TOWN OF CARMEL
ENVIRONMENTAL CONSERVATION BOARD

ENVIRONMENTAL CONSERVATION BOARD AGENDA

**Re: Lake Plaza Shopping Center
983-1005 Route 6,
Mahopac, NY 10541
Tax Map #65.10-1-45 & 46 – Site Plan Review**

State of New York
 County of Westchester
C-4.2
 Scale: 1/8" = 1'-0"
 Michael W. Agreba
 Professional Engineer
 NY Lic. No. 67202
 41928.00

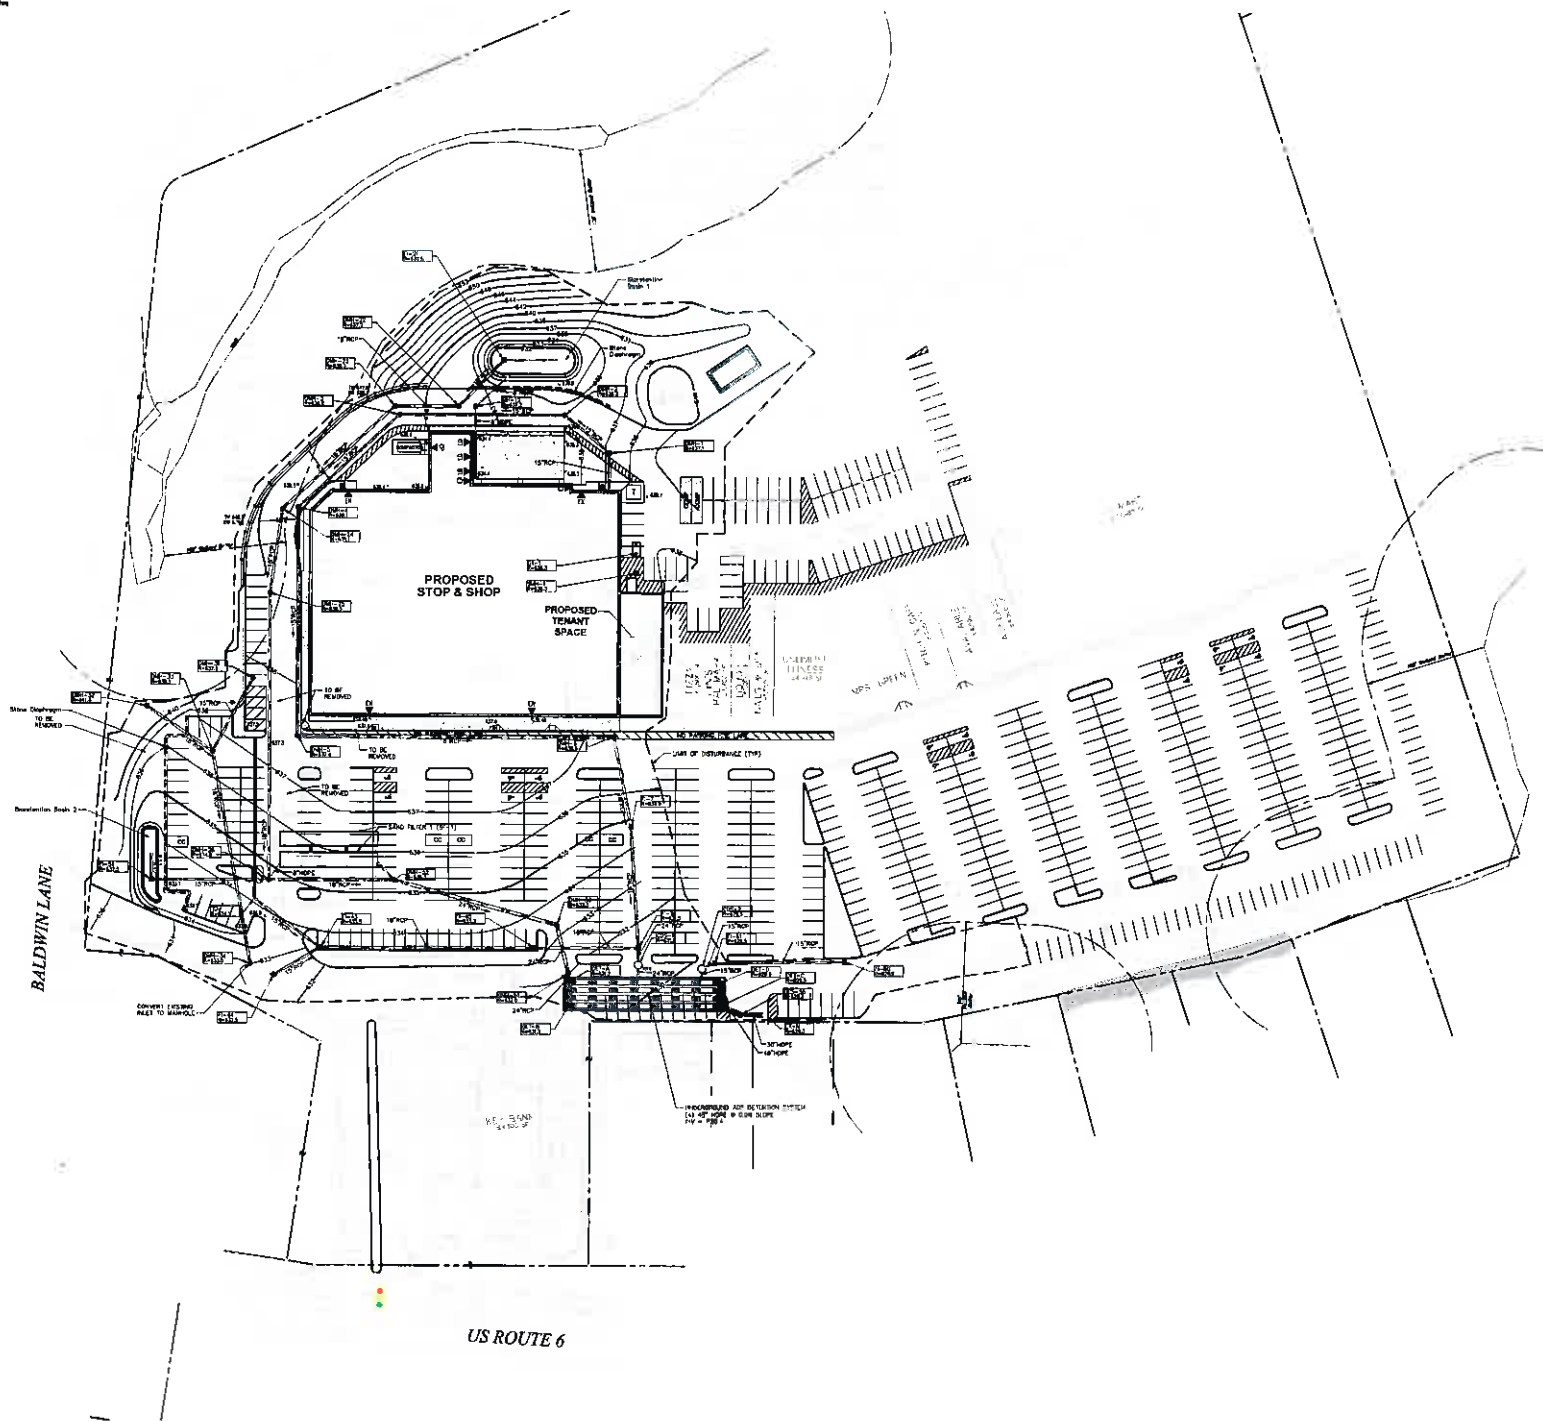
Comment #1: Applicant has acknowledged that Zoning/Parking Chart on Drawing C04 should identify the number of employees. The count is needed for the total future proposed number of employees for wastewater and number of parking spaces.

Response #1: **As indicated in Table 2-2 of the Urban Land Institute's publication, Shared Parking, 2nd Edition, a community shopping center such as the Lake Plaza facility would be expected to provide 4 parking spaces per 1000 sf of gross leasable area, of which 0.8 spaces per 1,000 sf would typically be provided for employees. Applying this value to the 164,000 sf center would suggest a maximum of 131 employees on site at any given time. Excluding K-Mart, the remaining approximately 82,000 sf of leasable retail space at Lake Plaza would need to provide 66 parking spaces to accommodate employees. A total of 86 spaces are provided in the rear of the center, which is more than adequate to accommodate this need. A note has been added to sheet C-04 indicating the number of employee.**

Plan Approved for Construction
 Grading and Drainage
 Plan

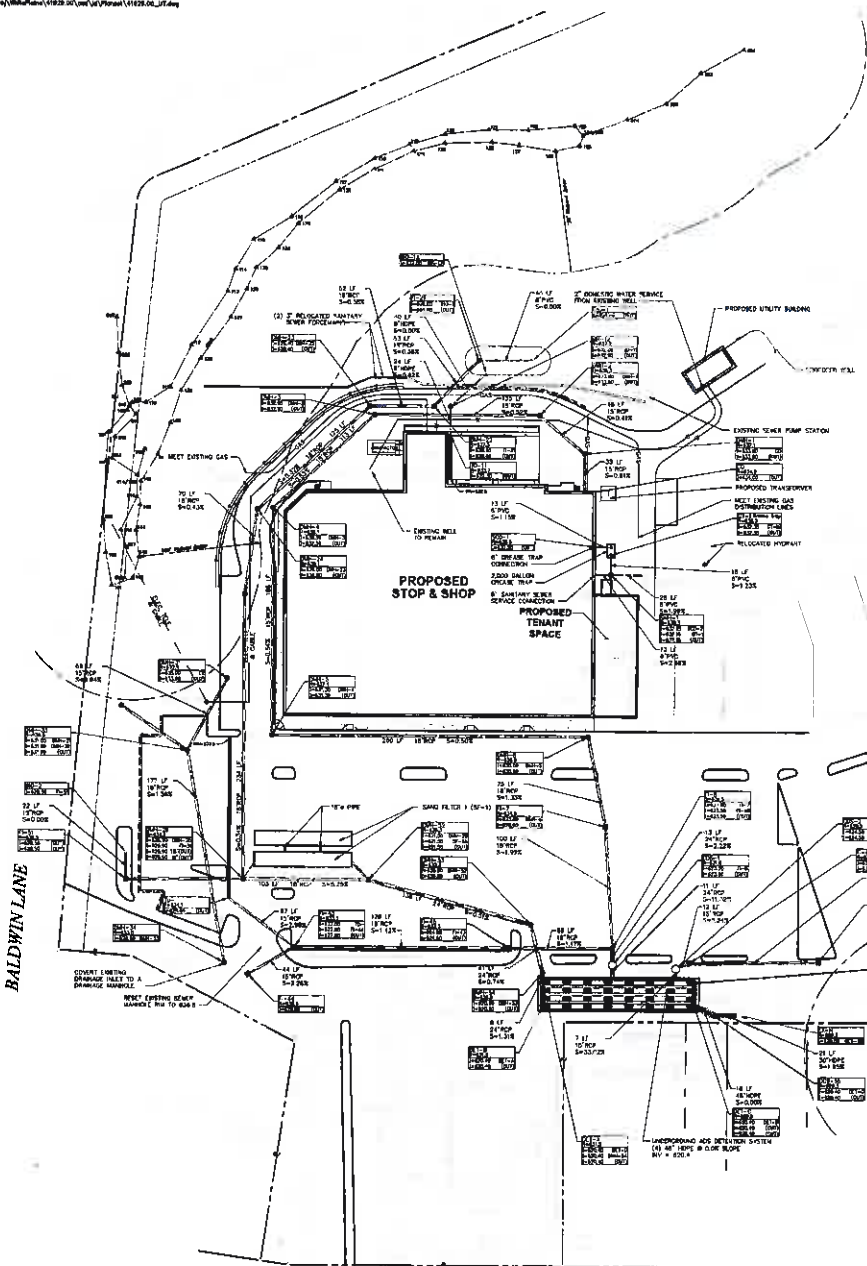
Comment #2: Drawing C-05 identifies a retaining wall on the east side of the property. In some areas the walls are nine (9) foot tall. The applicant has acknowledged that the wall calculations will be certified by a structural engineer.

Response #2: **Comment noted.**

C-06

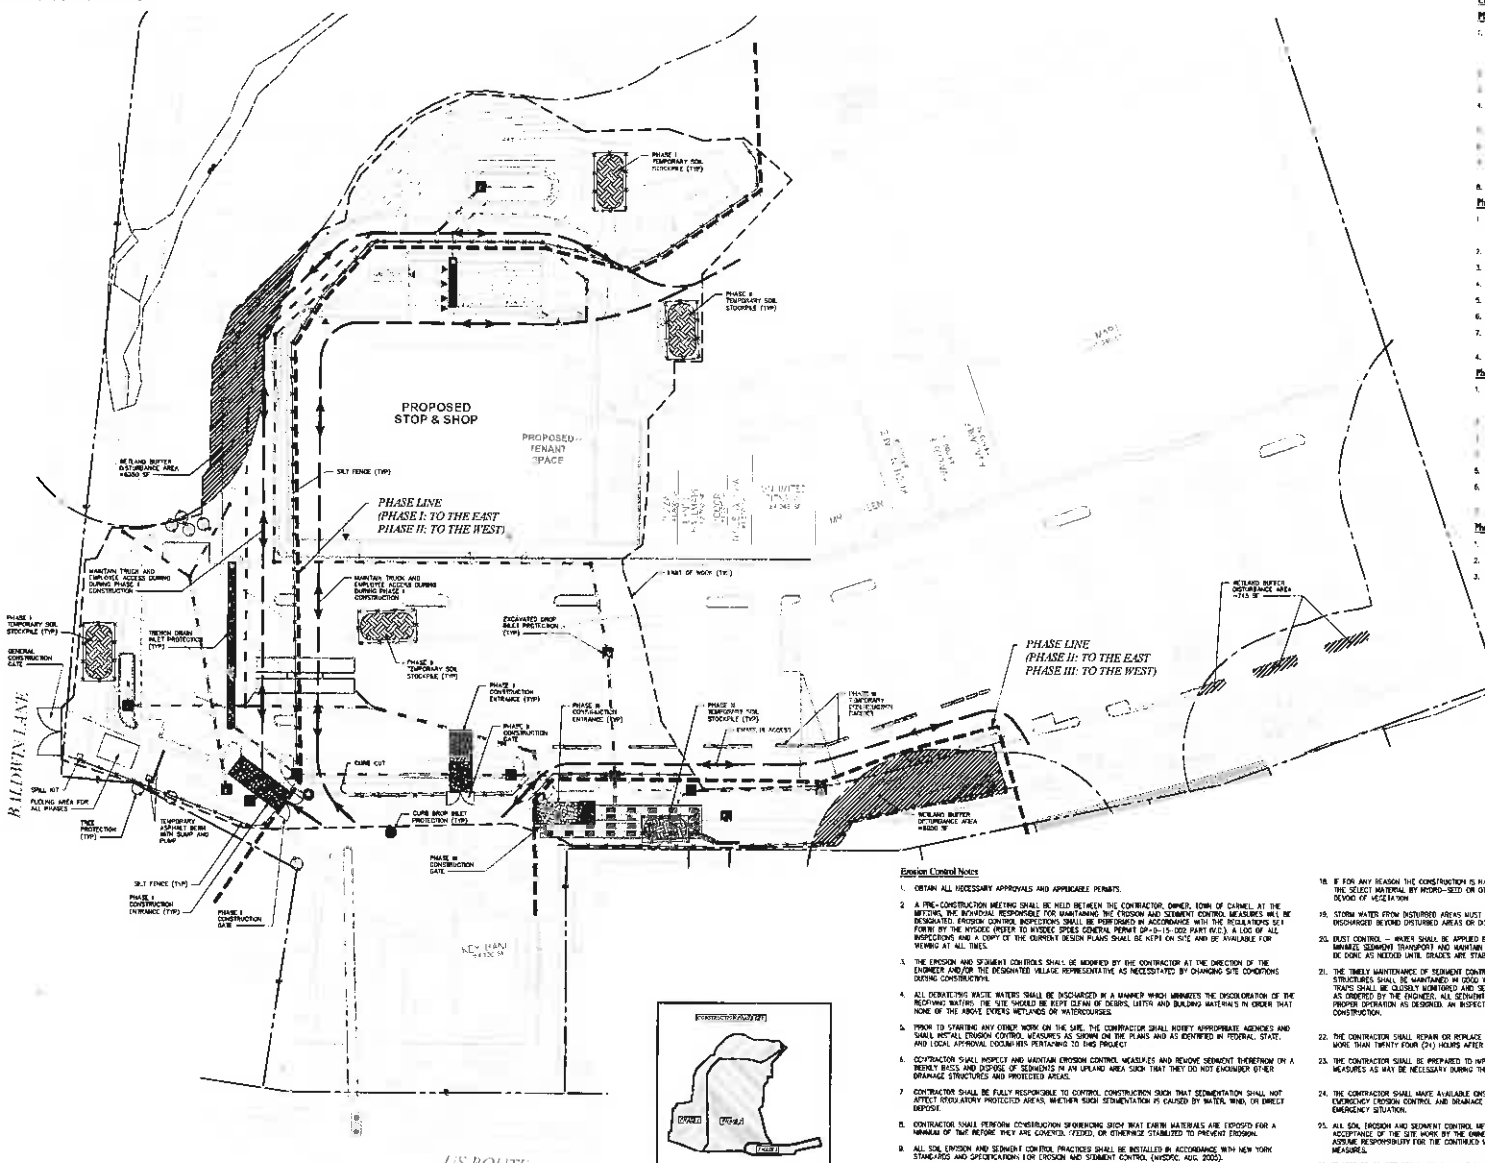
Comment #7: All sewers must meet the Town of Carmel Town Code § 120-29.

Comment #8: Sidewalks, manholes and guiderails should be installed per §128 of the Town of Carmel Town Code.

Comment #9: All water service connections must be K-copper.

Comment #10: Gate valves shall be AWWA non-rising stem type, as manufactured by Mueller Company, Model A-2360-23, or approved equal, conforming to the latest AWWA Standard for Gate Valves - 3" through 48" - for Water and Other Liquids, AWWA Designation C-509.

Comment #11: Sizes up to and including 12" shall be 250 psi working pressure. The valve body and bonnet shall be ductile iron. All interior and exterior metal surfaces shall be coated with a two-part thermosetting epoxy complying with AWWA C550.

Comment #12: Valves shall have dual "O" ring seals, inside screw, resilient wedge seats in accordance with AWWA Designation C-550 and shall be constructed so as to provide unobstructed full port clearance when fully open and immediate complete closure when closed. The ends of the valves shall be mechanical joint.

Comment #13: All valves shall be arranged to open in counter clockwise direction unless otherwise specifically indicated and operating nuts shall be 2" square.

Comment #14: Valves shall be tested to a pressure of not less than two times the working pressure.

Comment #15: All hydrants shall be six inches in size with six-inch mechanical joint inlet connection and shall be equal to the Mueller Centurion A-421, with one (1) 4.5" pumper nozzle and two (2) 2.5" hose nozzles.

Comment #16: Water Service Saddles shall be equal to those manufactured by Mueller, Model 7.5" x 1" SS Series Stainless Steel Saddle, Double Stud.

Comment #17: Corporation stops shall be equal to those as manufactured by Mueller Company, Model B- 2500Series, NRS and of the size required. Such corporation stops shall meet the requirements of AWWA Specification No. C800.

Comment #18: Curb valves (stops) shall be equal to those as manufactured by Mueller Company, Model H- 15214 and shall conform to AWWA Specification No. C800.

Comment #21: Fire hydrants shall be rated for a working pressure of 250 Psi. Fire hydrants shall be sized for a 4'-6" bury.

Response #7: **A note has been added to Utility Plan (Sheet C-06) to reflect this comment.**

Response #8: A note has been added to Utility Plan (Sheet C-06) to reflect this comment.

Response #9: A note has been added to Utility Plan (Sheet C-06) to reflect this comment.

Response #10: A note has been added to Utility Plan (Sheet C-06) to reflect this comment.

Response #11: A note has been added to Utility Plan (Sheet C-06) to reflect this comment.

Response #12: A note has been added to Utility Plan (Sheet C-06) to reflect this comment.

Response #13: A note has been added to Utility Plan (Sheet C-06) to reflect this comment.

Response #14: A note has been added to Utility Plan (Sheet C-06) to reflect this comment.

Response #15: A note has been added to Utility Plan (Sheet C-06) to reflect this comment.

Response #16: A note has been added to Utility Plan (Sheet C-06) to reflect this comment.

Response #17: A note has been added to Utility Plan (Sheet C-06) to reflect this comment.

Response #18: A note has been added to Utility Plan (Sheet C-06) to reflect this comment.

Response #21: A note has been added to Utility Plan (Sheet C-06) to reflect this comment.
